**Town of Kittery  
Planning Board Meeting  
August 8, 2019**

**ITEM 1 – 76 Dennett Road – Site Preliminary Plan Review**

**Re: Response to Review Comments**  
Proposed Mixed-Use Residential  
Development Project  
76 Dennett Road, Kittery, ME 03904

**RE: Town of Kittery, Planning Board Services  
Mixed-Use Development Proposal – 76 Dennett Road Lots 6-15B, 6-16A, 13-4  
Preliminary Plan Approval Application  
Review of HTA Responses dated July 25, 2019; and  
MDOT Traffic Movement Permit Application dated July 1, 2019  
CMA #591.125**

OVERALL SITE PLAN  
**C5**  
PROJECT NO. 569200  
SHEET 5 OF 25

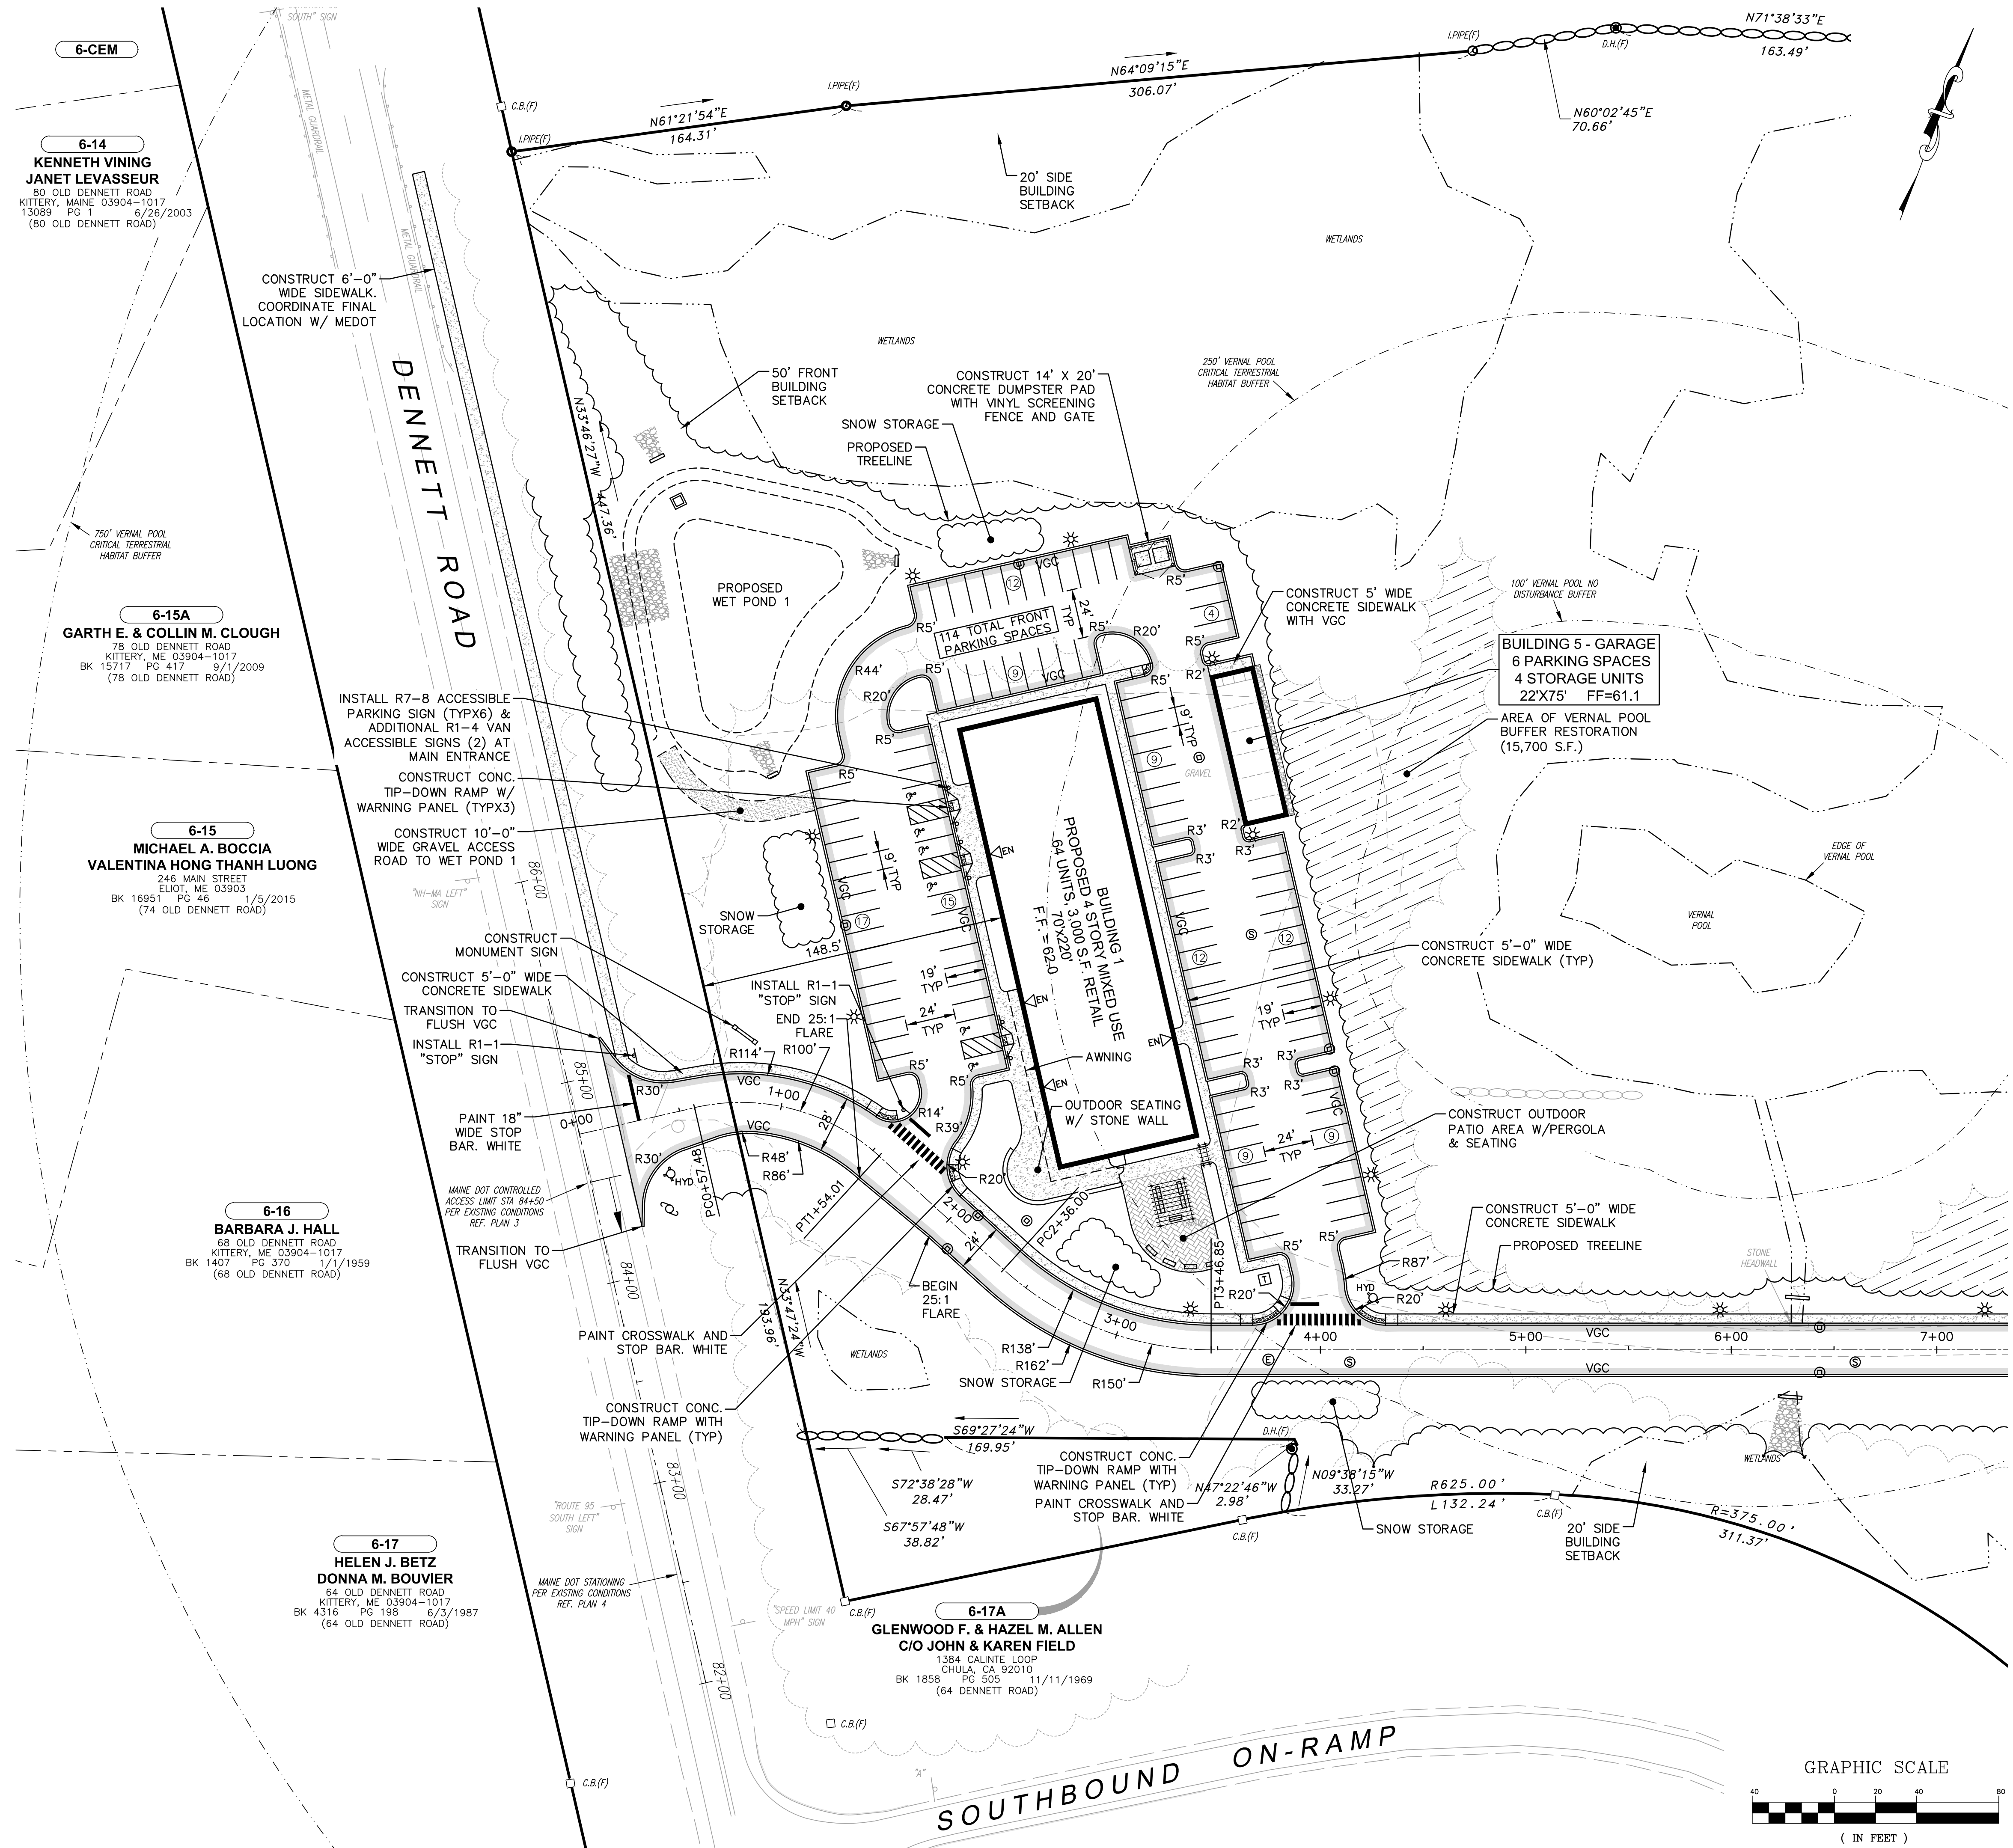
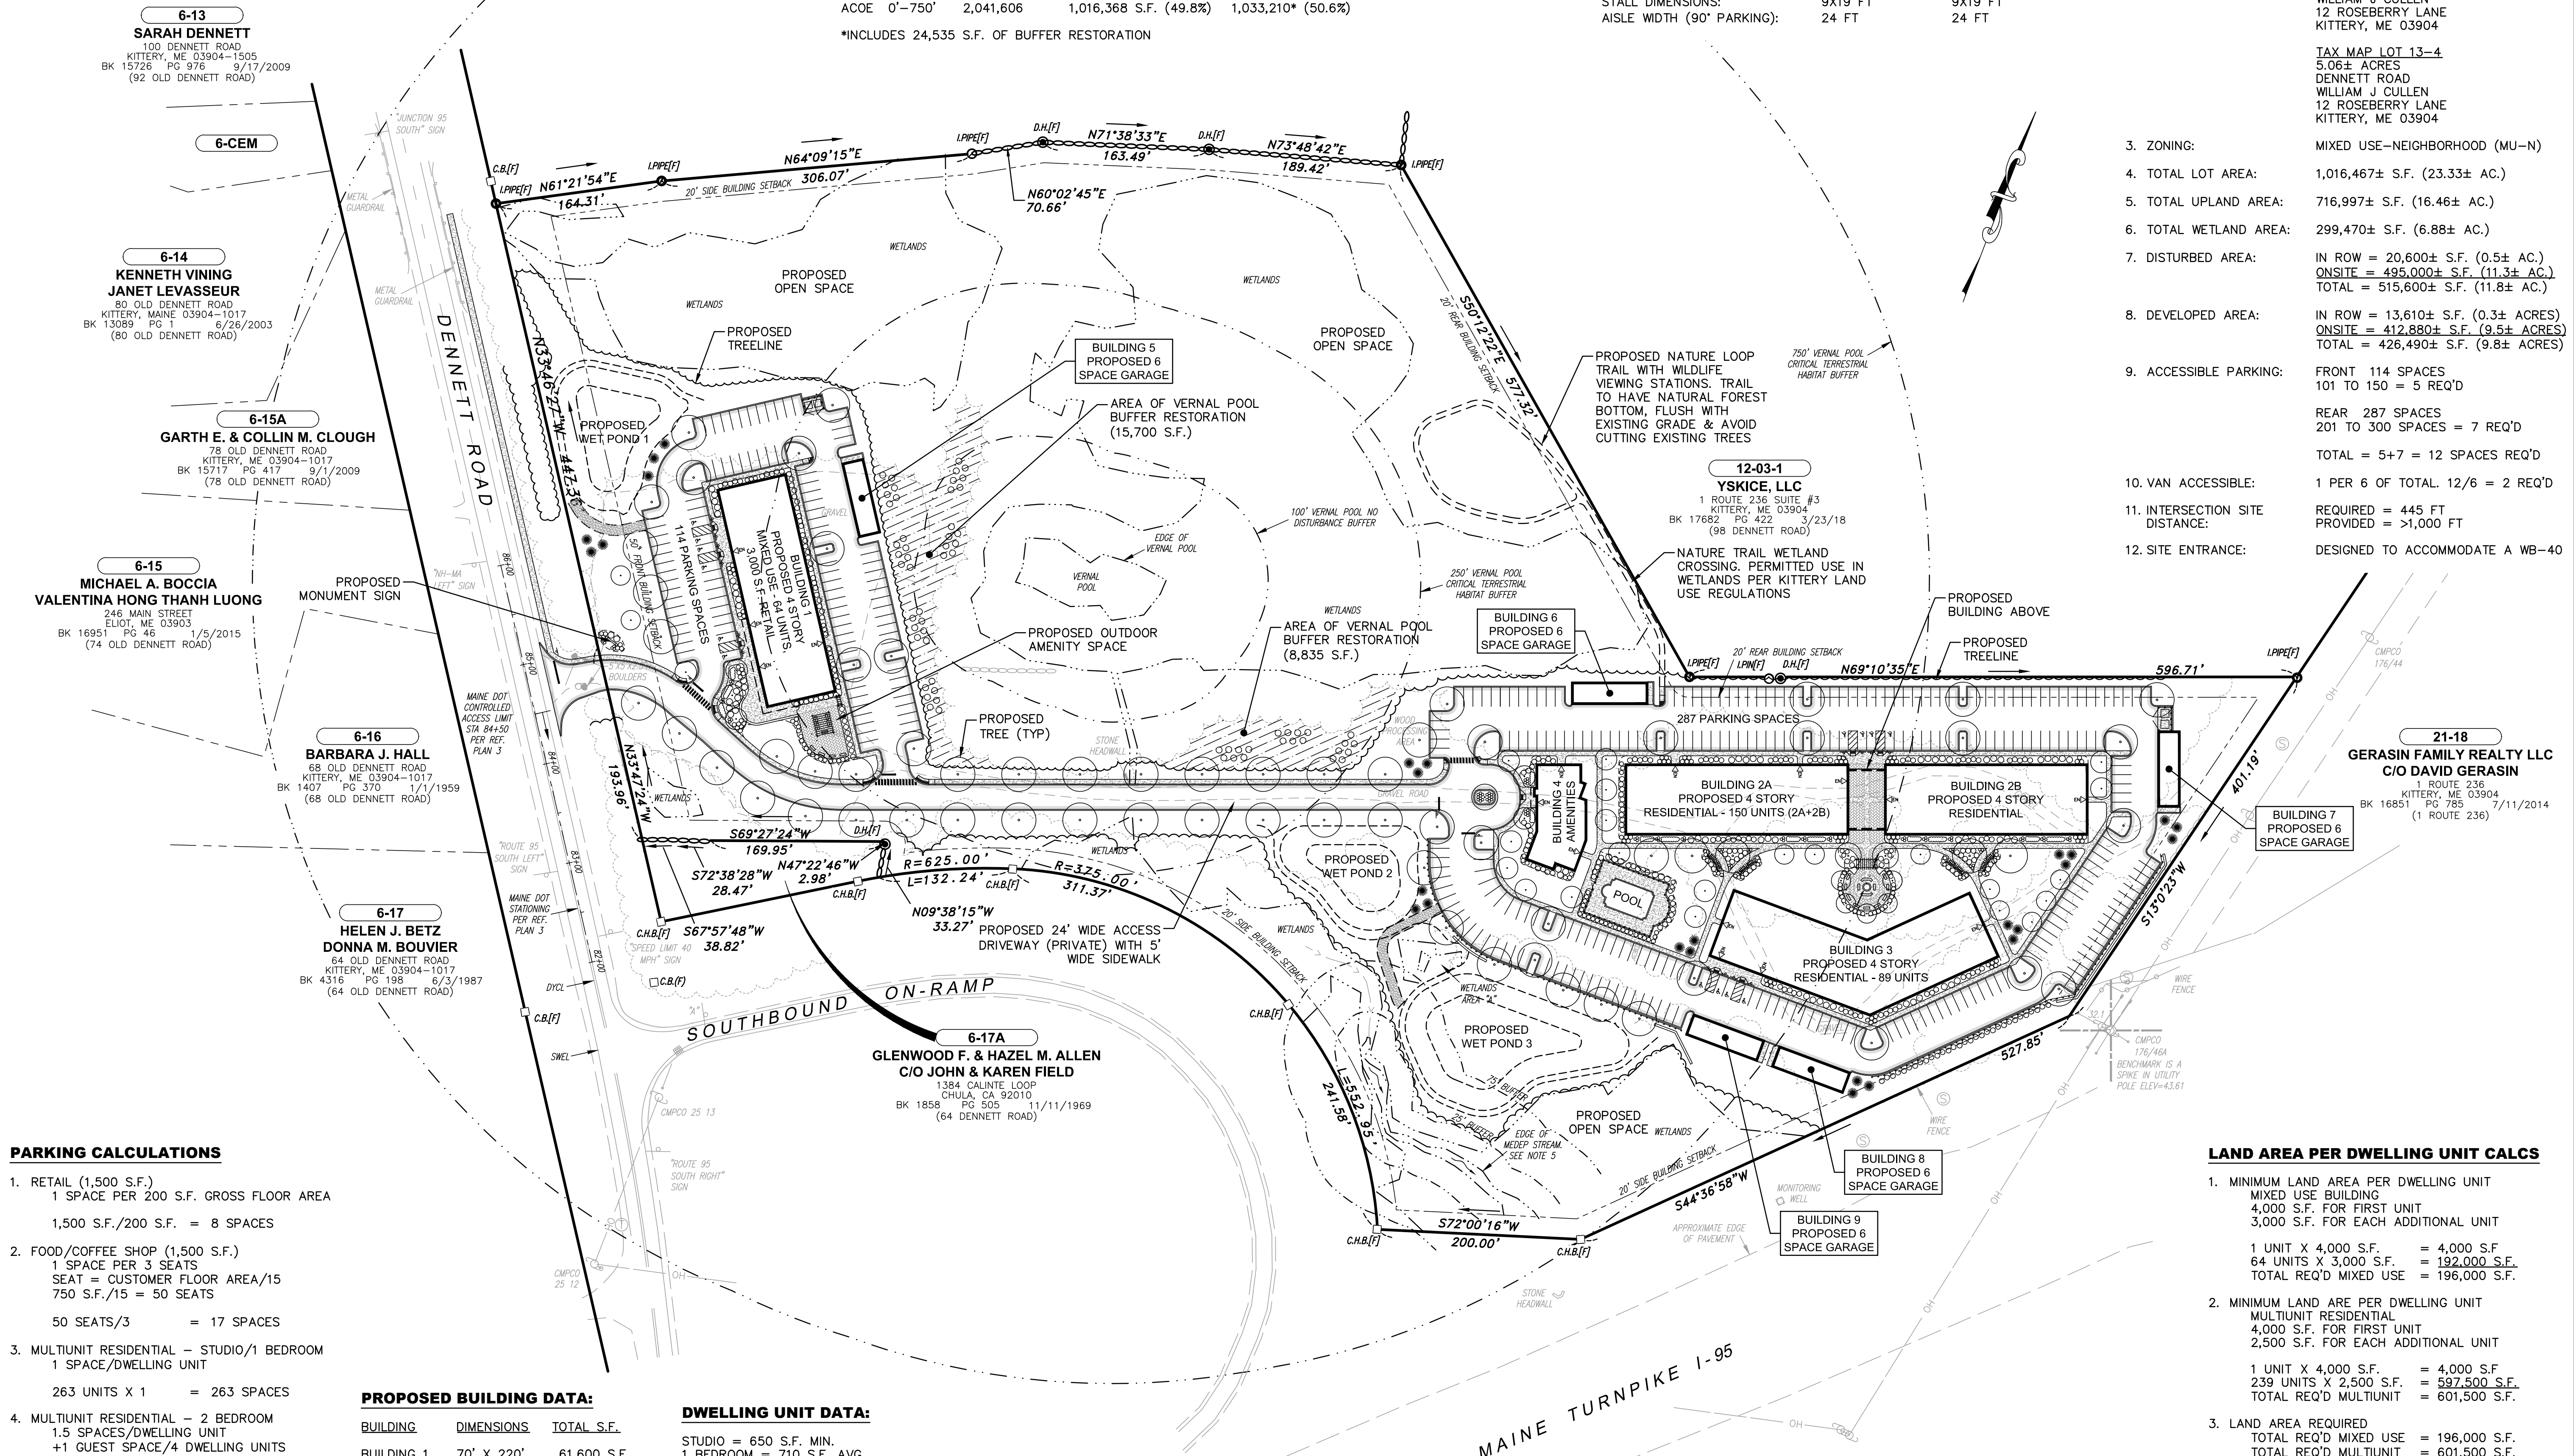
- *The site plan includes areas of significant open space. Much of it is wetlands, including a vernal pool. However, it is not designated with notes dedicating it as open space.*

- The site plan includes significant areas of open space. Much of it is wetlands, including the vernal pool. However, it is not designated with notes dedicating it as open space.
- The plan does include a limited network of walking trails.

***While the new notes call out Open Space, the designations are unclear as to the limits of designated open space. The horizontal limits of what will be designated Open Space should be presented on the plan.***

Notes have been added to the Overall Site Plan, Sheet C5 designating the areas as open space.

*"Notes have been added to the overall Site Plan, Sheet C5 designating the areas as open space."*
